The following changes in the tender documents are effective immediately. This addendum will form part of the contract documents.

**END OF ADDENDUM No. 2**

**WILLIAM HEAD INSTITUTION ELECTRICAL HIGH VOLTAGE UPGRADE (PHASE 2 OF 2)**

2 OUTDOOR UNIT SUBSTATION (US-103) GROUNDING DETAILS  
N.T.S.

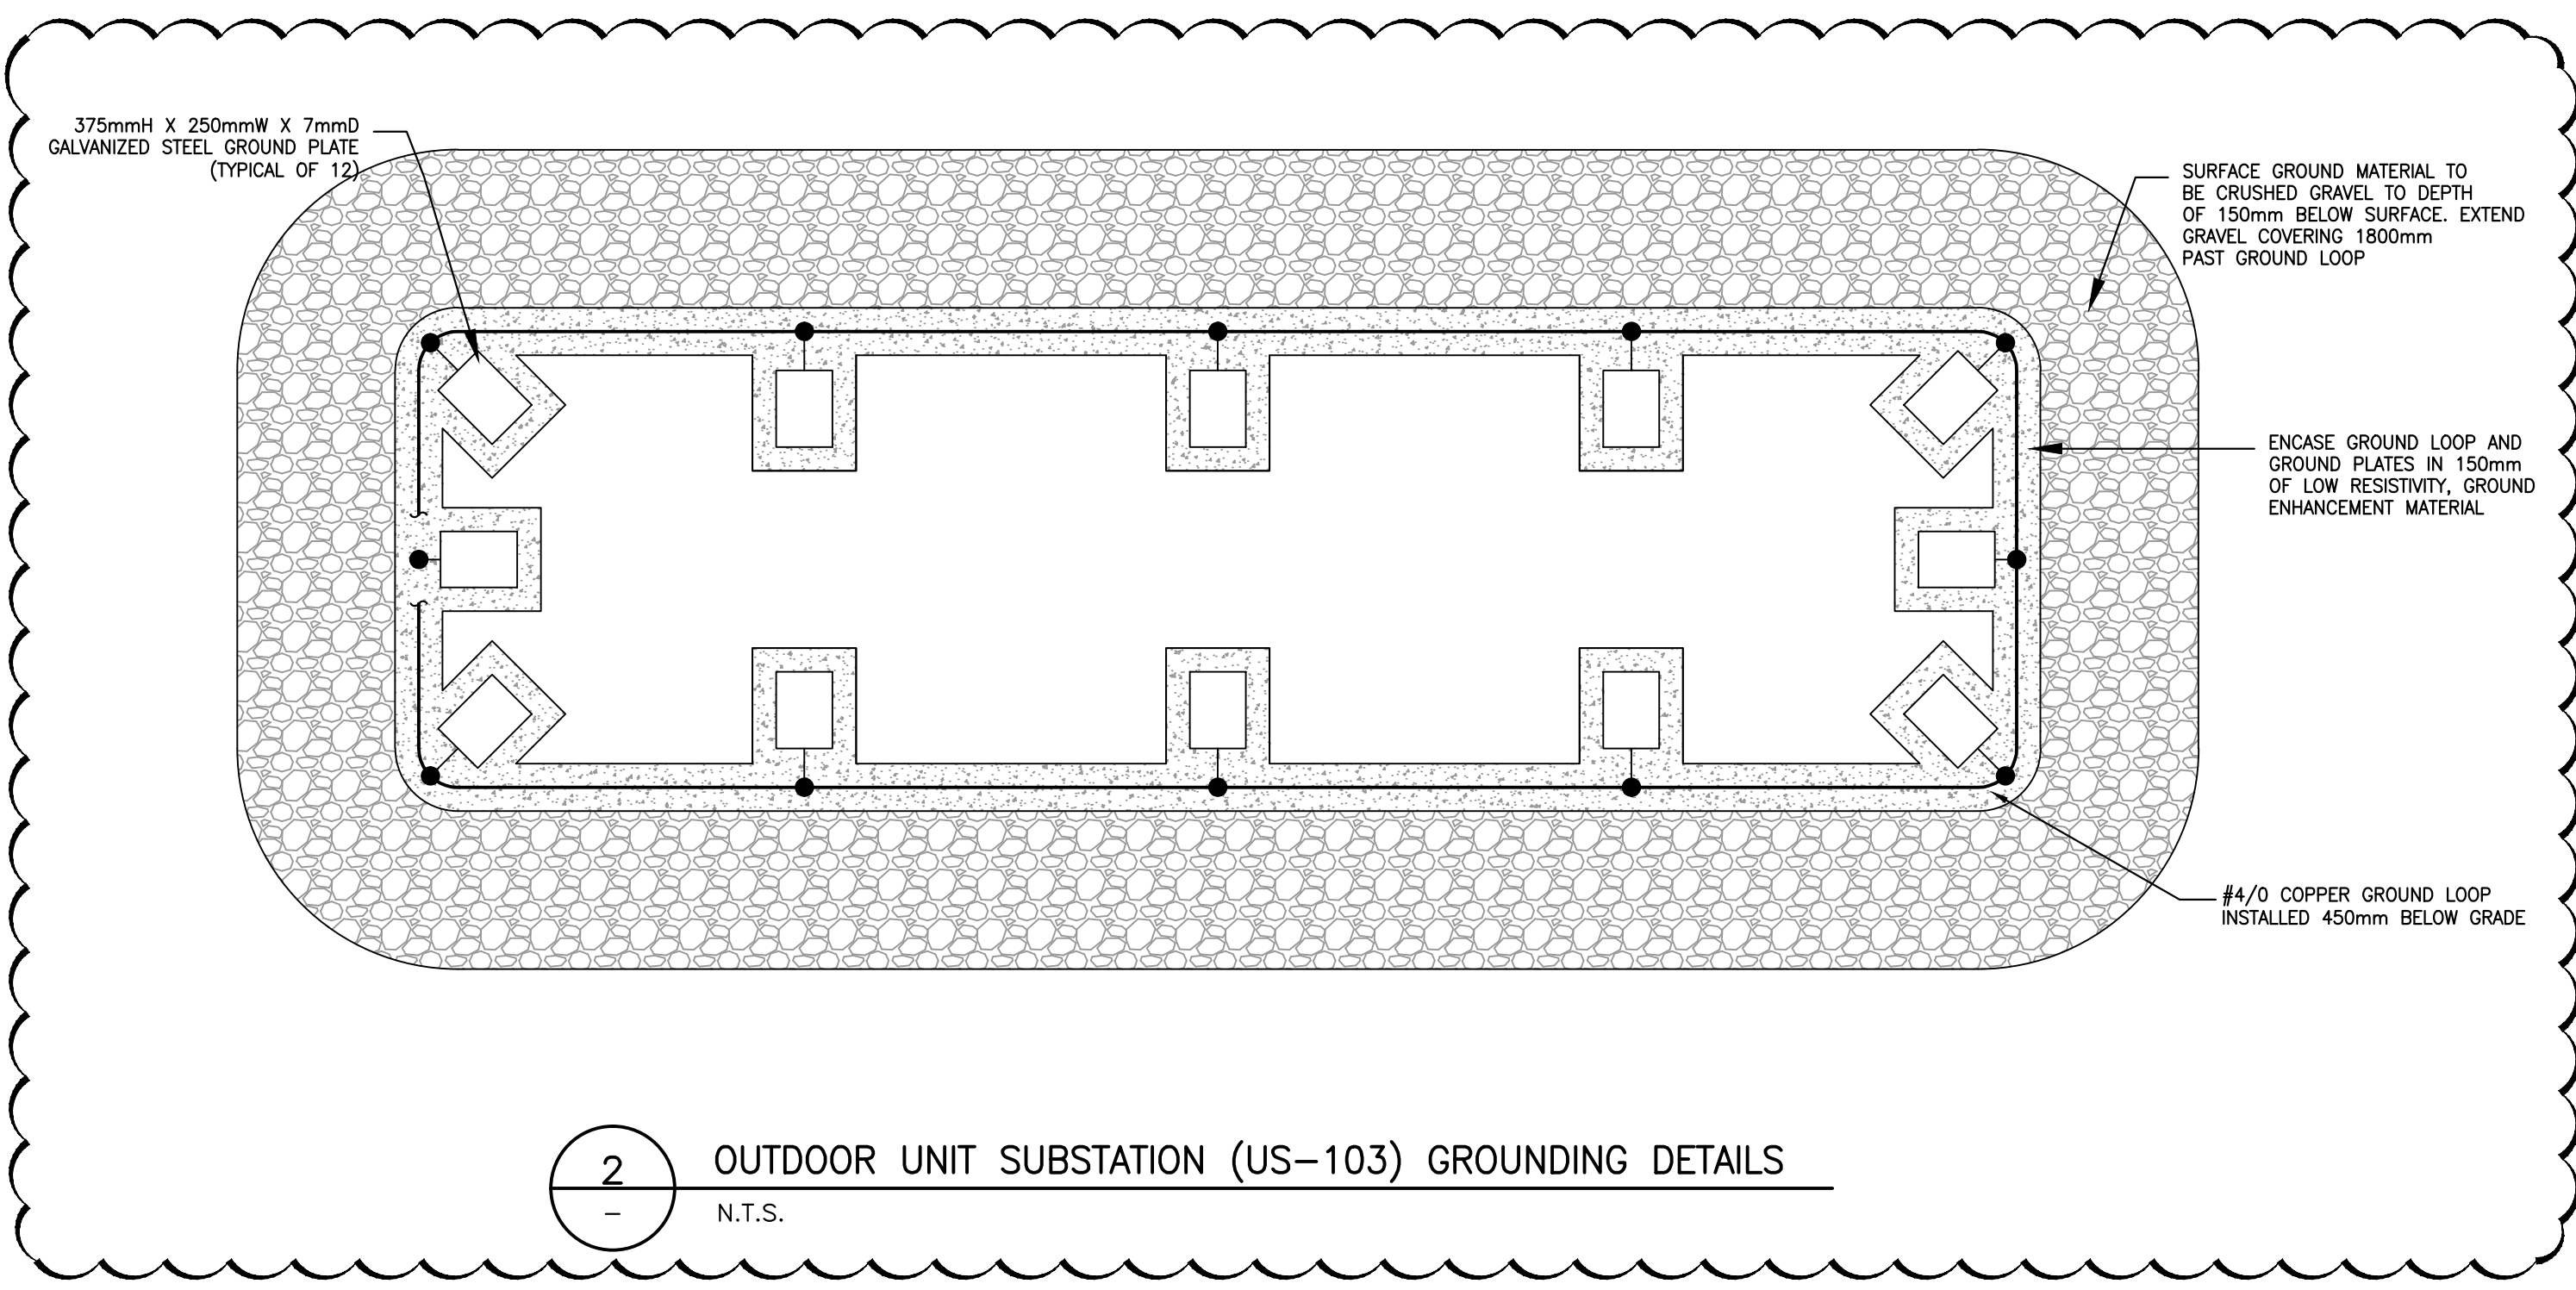
1. Revise grounding details as noted and add detail 6 for additional grounding requirements.

**I** TRENCH SECTION DETAIL – US-4 TO HV-18  
E-105 N.T.S.

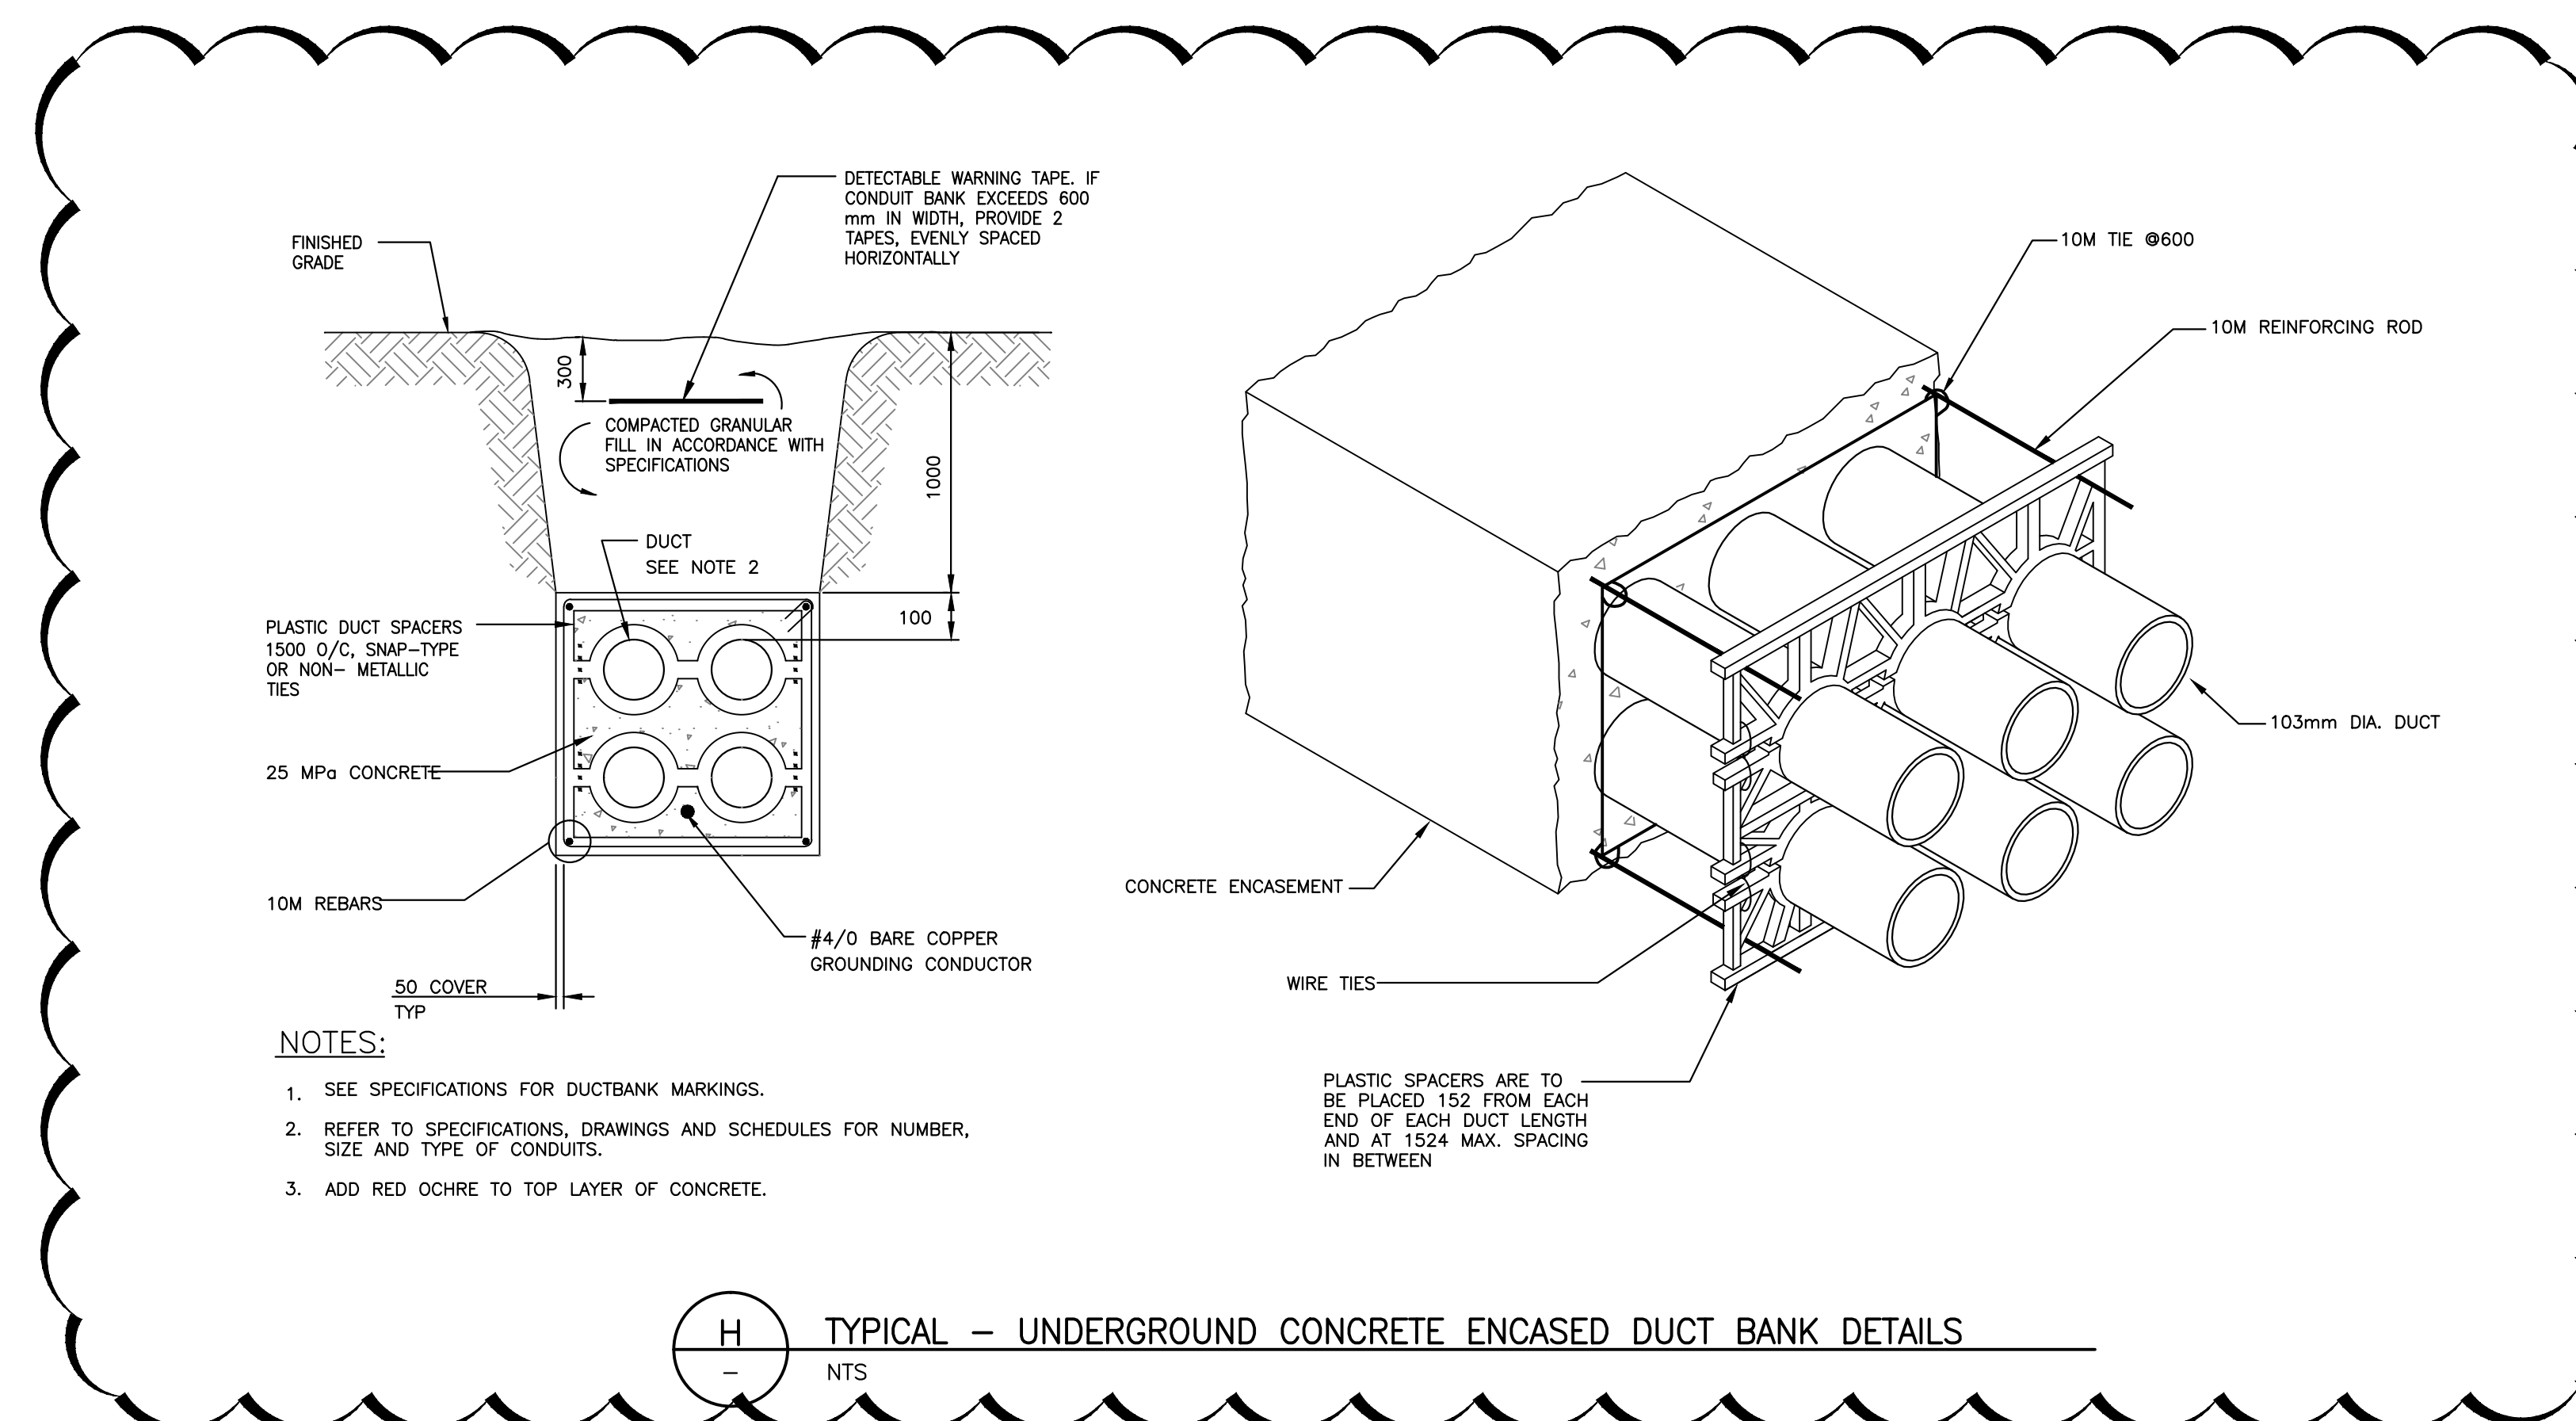
1. Add H/E-200 for typical details on concrete encased underground duct banks.
-
